2022 CIPP Package  
Solicitation Number: CO-00618

**ADDENDUM 3**  
**March 02, 2023**

2022 CIPP PACKAGE  
 (APPLEWHITE)  
 CIPP PLAN SHEET -  
 COMPKY 1011811 & 1011261

2022 CIPP PACKAGE  
**(APPLEWHITE)**  
BYPASS PLAN

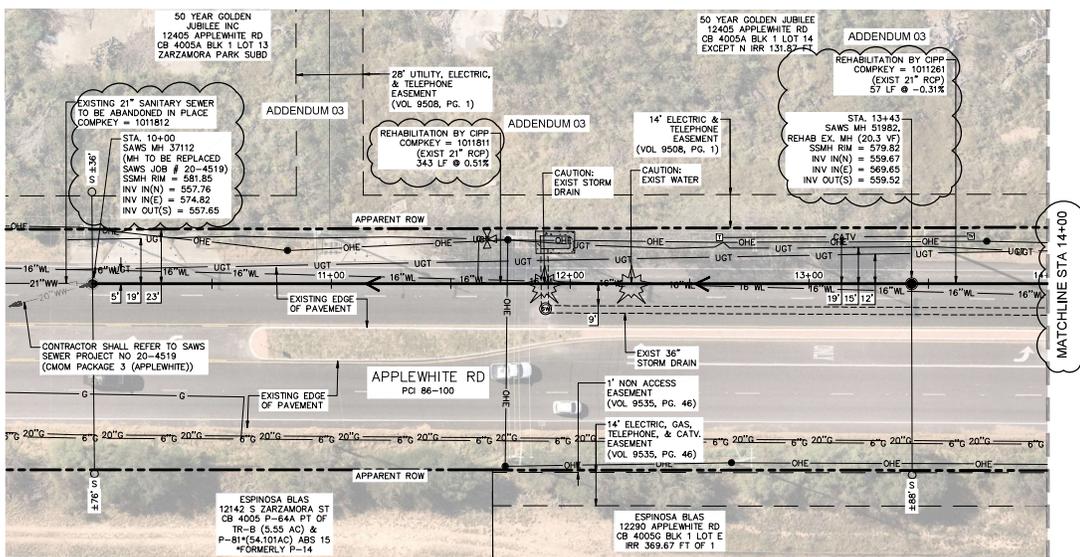
2. Applewhite - CIPP Plan Sheets (Sheets 8, 9 and 10 of 55) to be removed and replaced with the sheets attached to this Addendum.
  - a. The top of the rim and flowline elevations for the sanitary sewer main manholes have been revised.
  - b. Matchline labels have been revised.
  - c. Item 910 – Manhole Rehabilitation quantity has been revised

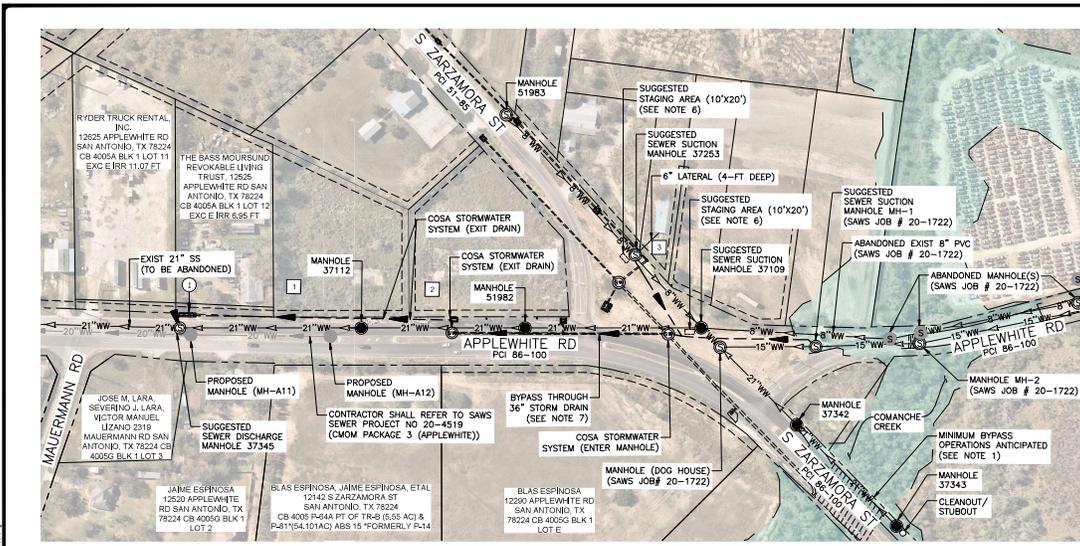
3. Applewhite – Bypass Plan Sheet (Sheet 11 of 55) to be removed and replaced with the sheet attached to this Addendum.
  - a. Note #9 has been revised.

02/28/2023 ADDENDUM 03 - UPDATED NOTE 9

9. CONTRACTOR TO REFER TO TRAFFIC CONTROL SHEETS FOR ADDITIONAL INFORMATION. THERE SHALL BE ADVANCE SCHEDULE COORDINATION BETWEEN CONTRACTORS TO ENSURE THERE IS NOT ANY CONSTRUCTION ACTIVITIES OCCURRING CONCURRENTLY FOR SAWS PROJECT NO. 20-4519 CDM PACKAGE 3 (APPLEWHITE) AND THIS PROJECT.
